Objection 2021/1860/P 11 Belsize Crescent Acoustic Report 25/10/2021

11 Belsize Crescent Acoustic Assessment

Figure 2.

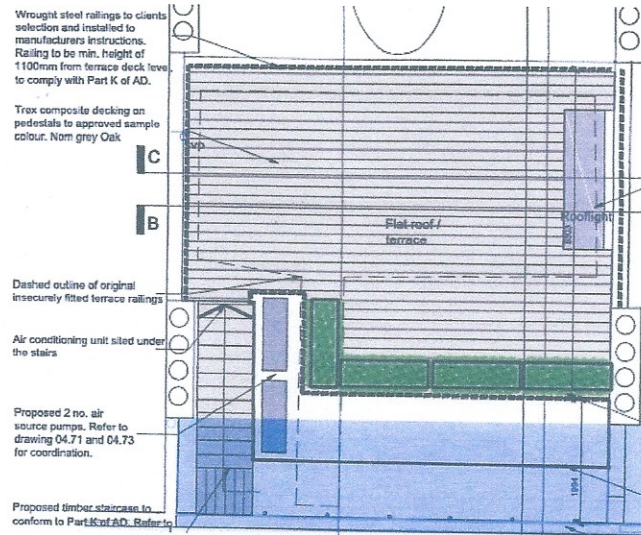
The report ignores the roof ventilation/light next to the low level party wall see pdf's below, the first is a copy and paste from the Acoustic Report, the second shows the missing roof vent/light indicated by the blue rectangle, the existence of this vent/roof light is evidenced on The third pdf of page 5 Figure 1

Figure 2.

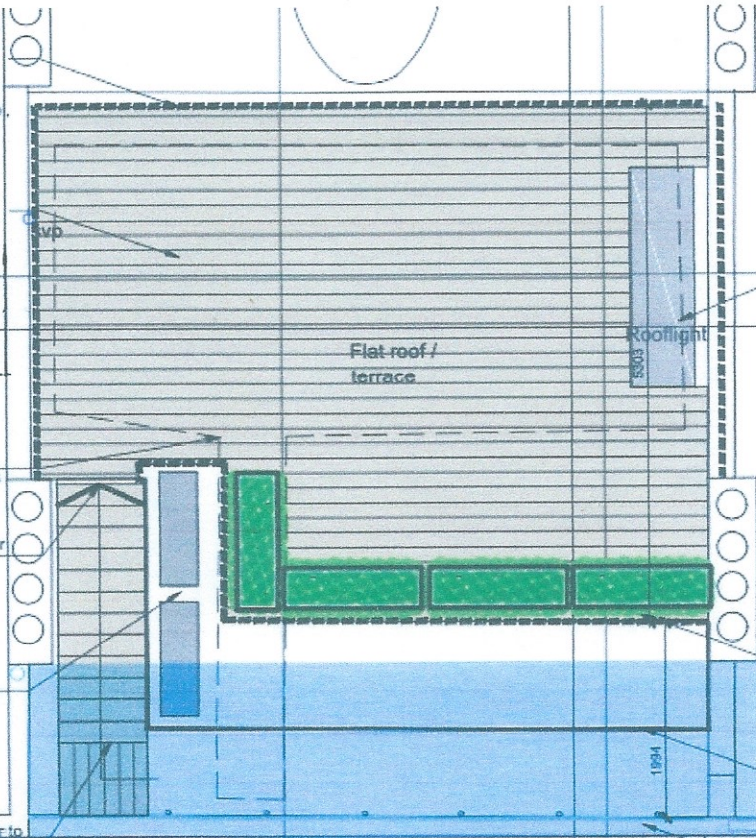
**ROOF LIGHT
VENT
IS BELSIZE CREAS**

This report starts at no problem with noise from the 2 Heat Pumps & Air Con Compressors as they will operate 24 hour below the background noise and won't be heard by neighbouring properties and then leaps to the need for acoustic barriers to reduce operational noise levels, the simple solution is to place the noise producing elements in the gardens and sound screened.

13 Belsize Crescent Vent/Roof Light from internal Bedroom 1

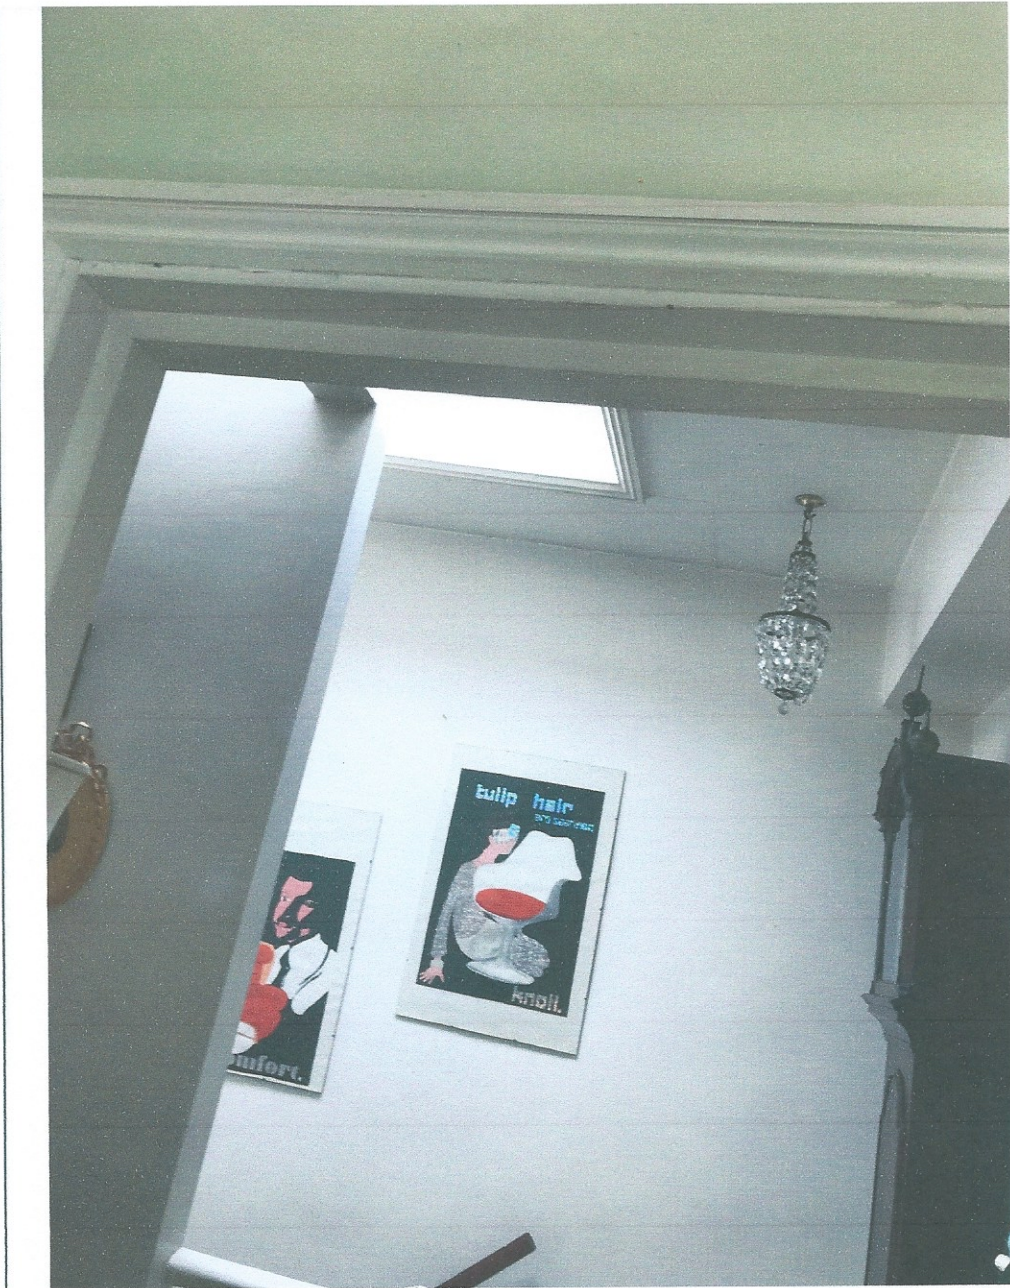
UNSHOWN ROOF LIGHT/VENT
